# Cherrybrook Station State Significant Precinct – Rezoning Proposal

Response to Submissions Report

*Figure 4: Indicative land use and built form map within the Design Guide (as exhibited)*

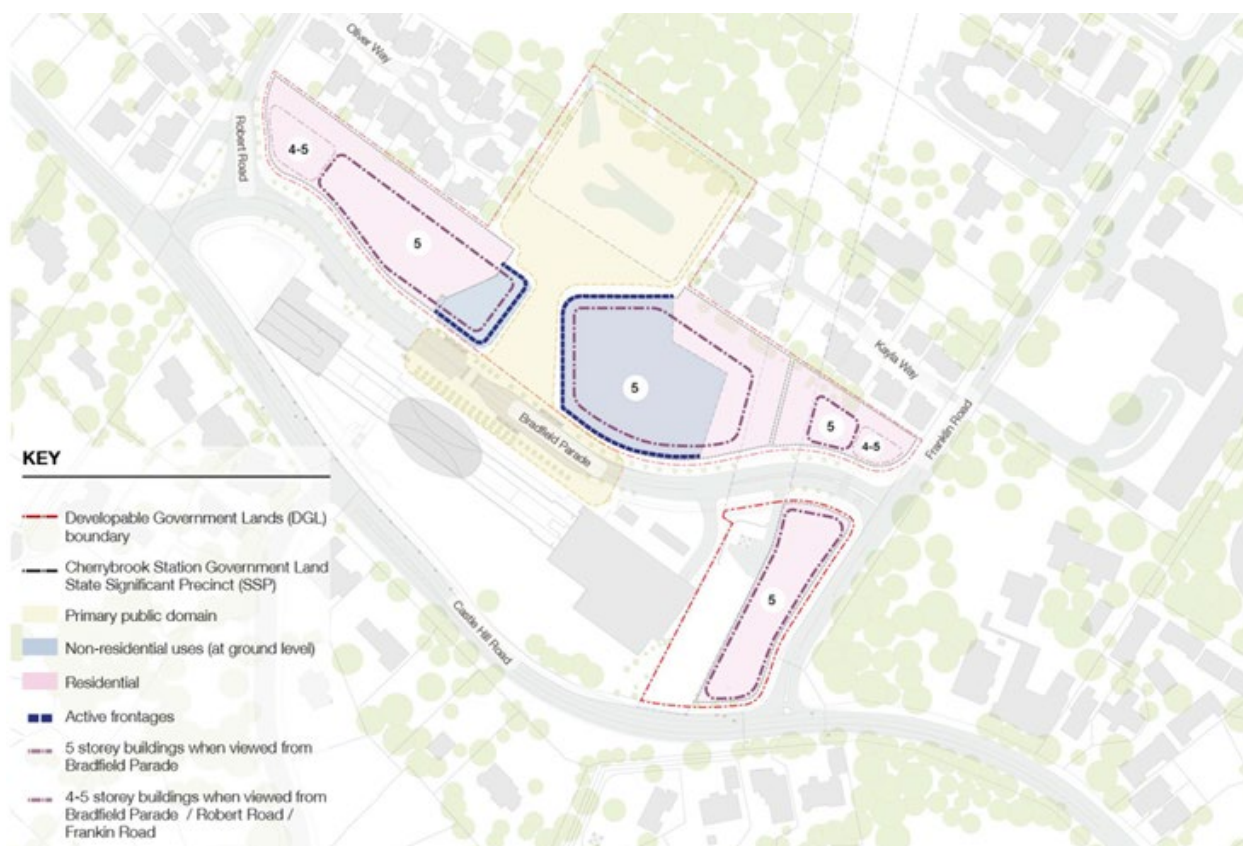
Council is concerned that the proposed maximum building heights of 18.5m to 20.5m are inconsistent with a 5-storey built form, do not align with the maximum building height of 16.5m under the HLEP 2013 for 5 storey precincts and would potentially allow additional storeys being proposed in contradiction to what is shown in the reference scheme. Council recommends that the proposed maximum building height be reduced and further consideration of the planning provisions for residential flat buildings within the HLEP 2013 and HDCP 2013 be undertaken.

It is noted that the proposed amendments (as exhibited) to the maximum building height control in the Hornsby LEP 2013 are greater than that which is provided for in the LEP for development up to 5 storeys in height. The Urban Design Study prepared by SJB which has informed the preparation of the planning framework for the rezoning proposal has outlined that a greater height limit in metres, relative to other 5 storey precincts, is proposed for the following reasons:

To reinforce the intended 5 storey height limit (as exhibited) for the SSP when viewed from Bradfield Parade, a Design Guide was prepared for the rezoning proposal. This included prescriptive measures in Section 1.10 which specifically related to a maximum number of storeys for development within the SSP. Prescriptive measure 1.2 required development to not exceed the maximum number of storeys shown on the Indicative Land Use and Built Form Map (**Figure 4**), noting that the maximum number of storeys in the SSP is 5 storeys (when viewed from Bradfield Parade) on this map. Notwithstanding the above, Prescriptive measure 1.3 of section 1.10 Built Form of the Design Guide allowed for an additional lower ground floor level when viewed from the north in the B4 – Mixed Use Zone, to respond to the topography of the site and activate the public open space at the lower level.

Based on the above, the Design Guide has been revised to include a change to the number of storeys control, to reflect a height incentive provision of 23.5m (which will allow up to 6 storeys when viewed from Bradfield Parade, or 7 storeys when viewed from the north).
